Product Change Notification

Change Notification #: 839992-00

Change Title: Intel® Wi-Fi 7 BE201, 1216, 2x2 BE+BT, vPro,

BE+BT No vPro, Label, Regulatory Label Updates

BE201.D2WG.NV Disti Label - Before

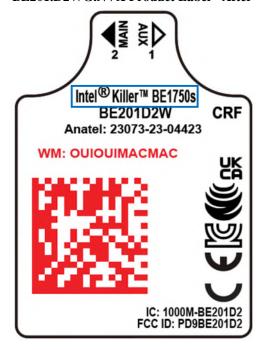
- 1. Update Killer product name on the product and Disti labels for BE201.D2WG.NVX.
- 2. Update Oman TRA product marking on the Disti label.
- 3. Update the box around Singapore IMDA's compliance marking on the Disti label.
- 4. Update text alignment on Japan Giteki MIC logo on the Disti label.
- 5. The Intel Tracking revision will be changed on the following products.

BE201.D2WG.NV Disti Label - After
